From: Brian Osborn [bosborn@gulfportenergy.com]
Sent: Monday, March 05, 2012 3:14 PM
To: Westerdale, Barbara; Andrews, David; Krabacher, Jay
Cc: David Segobia
Subject: RE: API 05-081-07666 (Ellgen 11-10-1 ST1)

Gulfport Energy Corporation Downhole Schematic

PROPOSED
WELLBORE

WELL NAME: ELLGEN 11-10-1 ST1	FIELD: Craig (13500)	API: 05-081-07666
SURFACE LOCATION: 759' FNL & 719' FWL (NWNW) Sec 10 - T6N - R91W Moffat County, CO		
ELEVATIONS: KB - CHF 14.6' KB 6363.0' DF 6362.0' GL 6348.5'	LAT: 40.497407	LONG: -107.597896
B. Osborn 11/12/2011	SPUD DATE: 09/05/2011

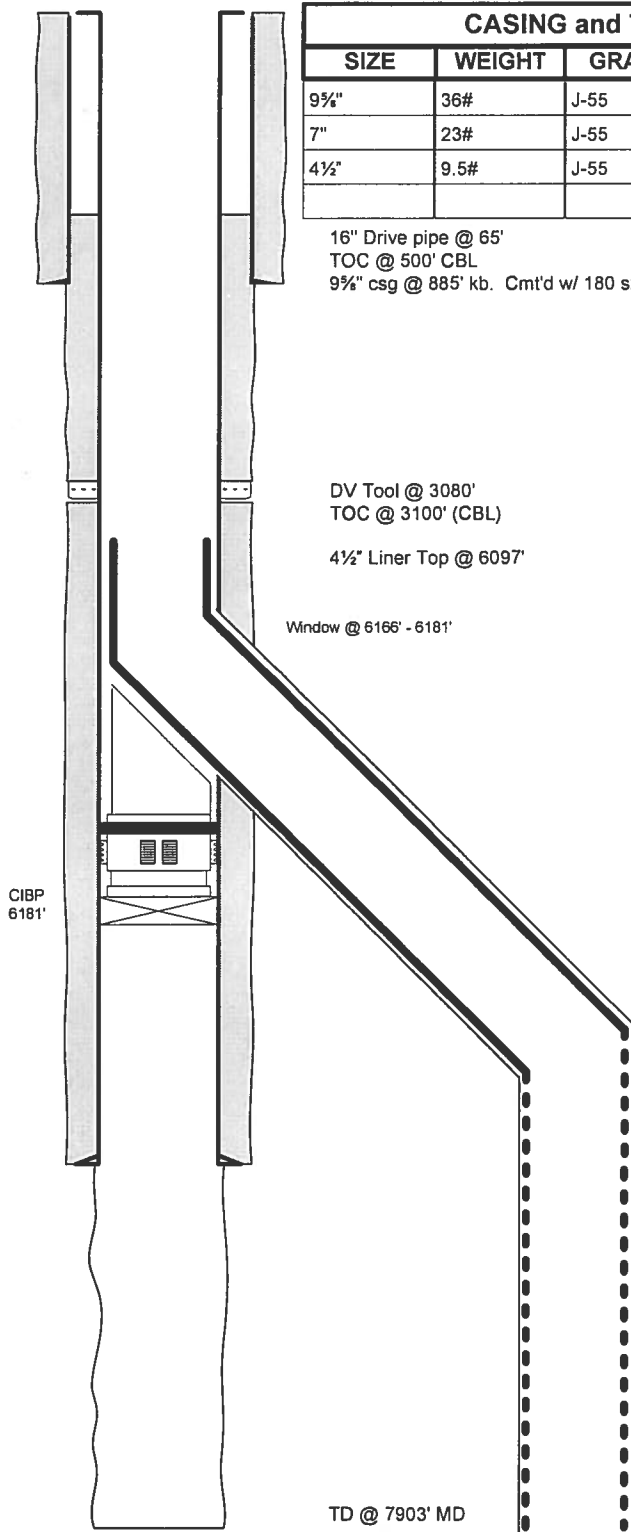
I have reviewed the new BHL footages: I calculate 764 FNL and 716 FWL. This is a legal location and meets the requirements of Spacing Order 199-5, approved 8/8/2011. This order established the W/2 of Sec. 10 as the drilling and spacing unit.

The new TD of 7903' is shallower than the originally proposed TD of 8300'.

This email acknowledges Jay's verbal approval to proceed. Please reply with missing information denoted by "???" (items i. and iv. below), per Step 1.b. of the attached guidance document. The guidance document also specifies form submittal requirements.

- i. Explain the situation that has resulted in the need to sidetrack
??? Unable to clean out the openhole to TD and run a slotted liner, therefore we need to drill a new hole and run a slotted liner.

- ii. Total depth reached
7903' MD shown on the wellbore diagram
- iii. Casing set – size(s) and depth(s)
16" conductor @ 65', 9-5/8" surface @ 885', and 7" intermediate @ 6365' shown on wellbore diagram

- iv. Description of fish in the hole (if any) – including top and bottom
??? there is not a fish in the well.
- v. Proposed plug setting depths, heights, and cement volumes
CIBP @ 6181' shown on wellbore diagram

- vi. Proposed sidetrack kick-off point
Cut window @ 6166' to 6181' shown on wellbore diagram
- vii. Proposed objective formation(s) for sidetrack hole – new or same as original hole
Barbara to evaluate using attached planned directional survey information

- viii. BHL Target for sidetrack hole – new or same as original hole (NOTE: a change in the BHL must be reviewed and approved by COGCC Permitting. Drilling a sidetrack to an unapproved BHL could result in an NOAV, plugging the well, or both.)
&nbs p; **Barbara to evaluate using attached planned directional survey information**
